RECEIPT DATE: 10-18-16 **ONSITE SEWAGE DISPOSAL SYSTEM** P 558865

APPROVAL DATE: 1-26-17 **PERMIT: CONSTRUCTION** A _____

PROPERTY ADDRESS: 2045 Drovers Lane

SUBDIVISION: Vista Ridge LOT: 16 TAX ID: 04-595481

PLAN VIEW
1" = 30'

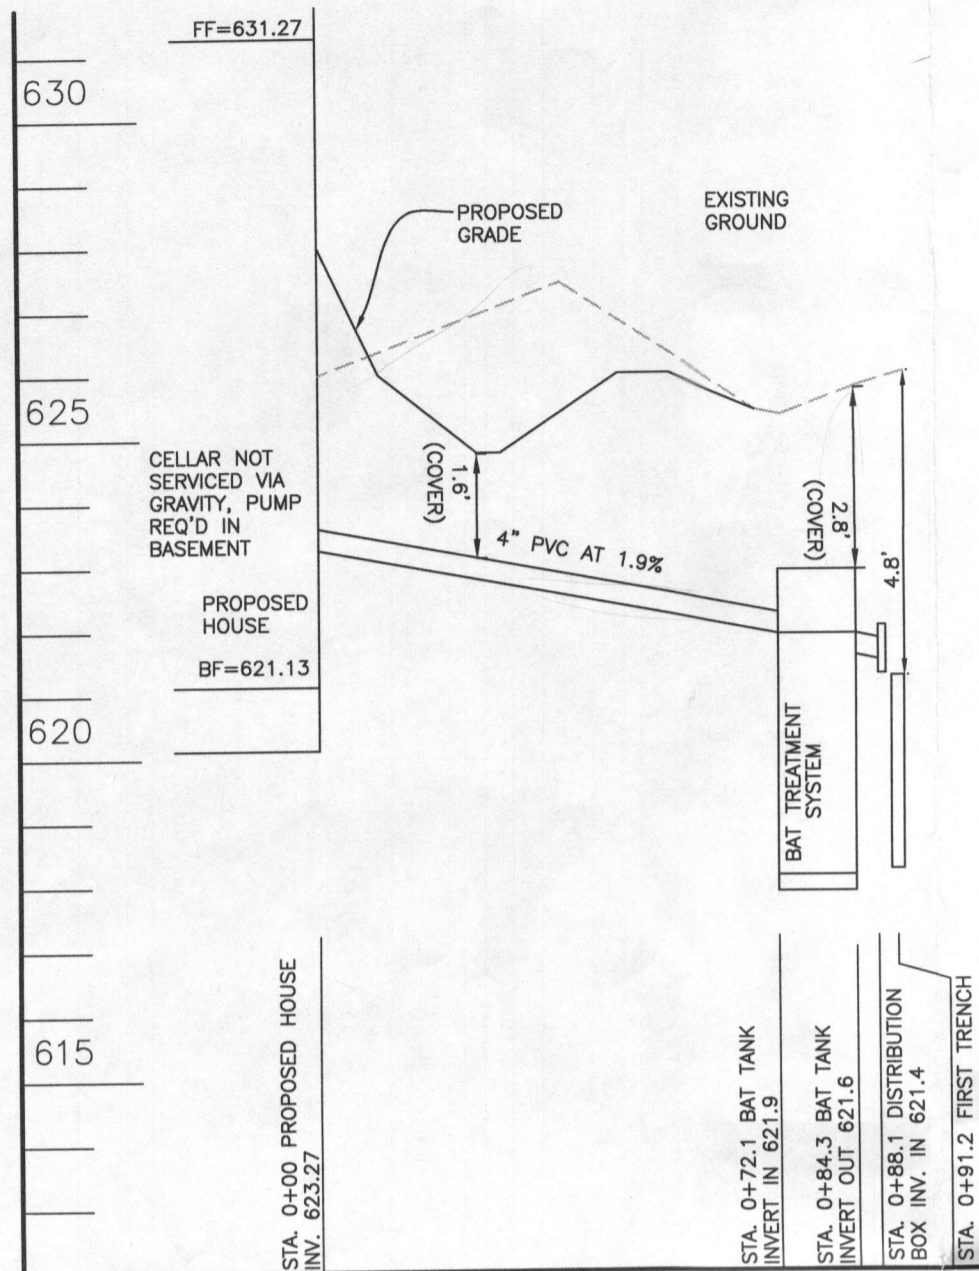
Replacement system to maximize width + use center feed trenches to leave room for 3rd system
